Image 30: View montage from balcony of Unit 7/2-6 Schwebel Street, Marrickville.

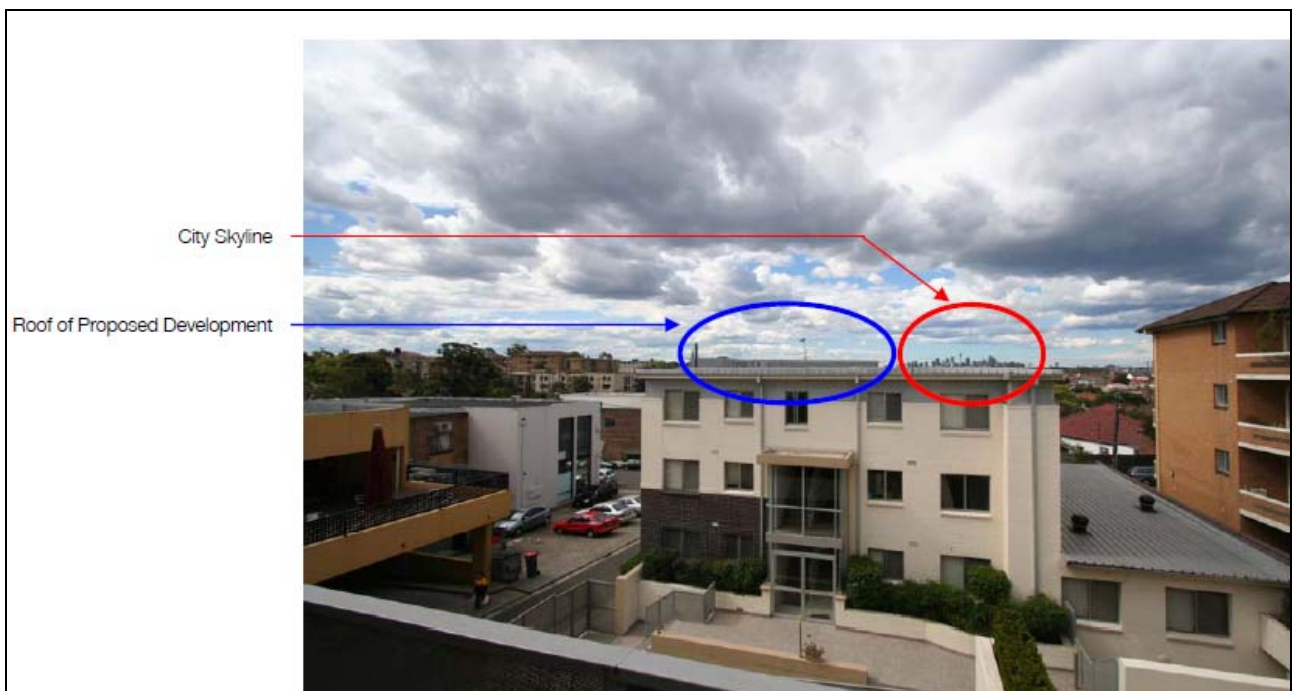
Based on Council officer's estimates and in accordance with the view sharing principles used by the Land and Environment Court, the views enjoyed are considered be of

valuable iconic views. The development proposes the majority of the building mass along the Illawarra Road frontage of the site with the proposed building stepping down towards the rear of the site. This is considered to be an appropriate design response and a significant improvement from the previous development proposed on the site, as it encourages view sharing for properties along Schwebel Street.

The proposed development will obstruct a small portion of the residential properties located along Schwebel Street, specifically ground floor residential development located along Schwebel Street. It is considered that it would be difficult to retain any view corridors for those properties and in light of this assessment the extent of view loss is considered acceptable.”

Image 19: View montage from balcony of Unit 2/8-10 Schwebel Street, Marrickville of the existing approved development

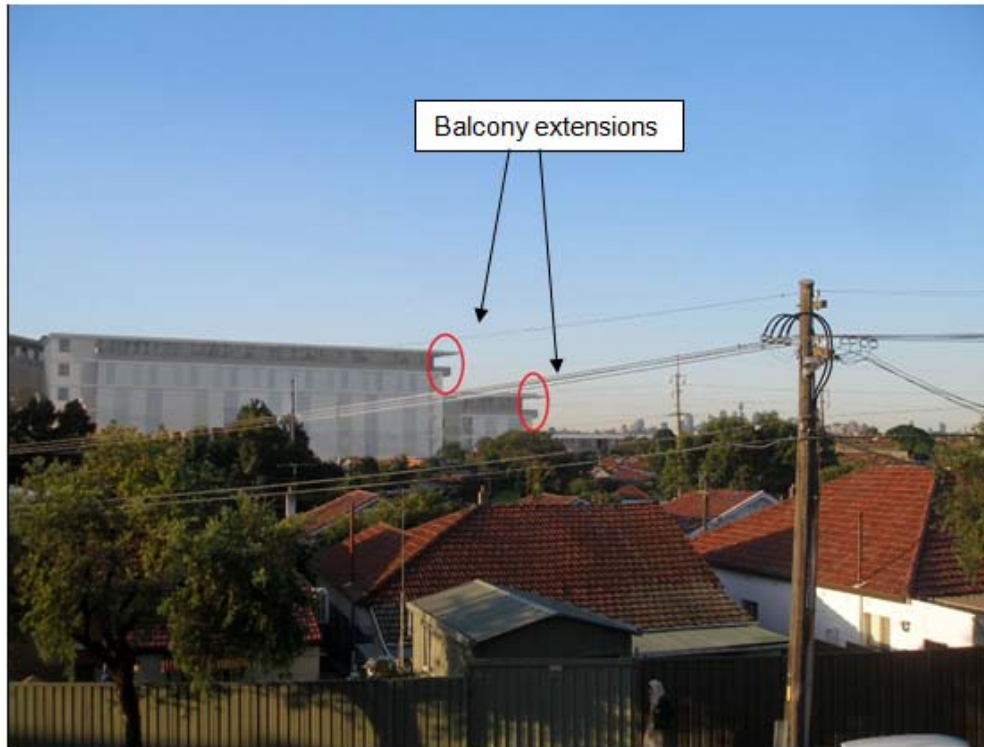
Unit 2/8-10 Schwebel Street, Marrickville is considered to be one of the most affected properties in regards to view loss, as a result of the subject development. As detailed in the photomontages the proposed modifications would result in some minor additional view loss for the residential properties at Schwebel Street, compared to the approved development. However iconic views of the CBD skyline would be retained. In view of the circumstances the extent of view loss is considered acceptable.
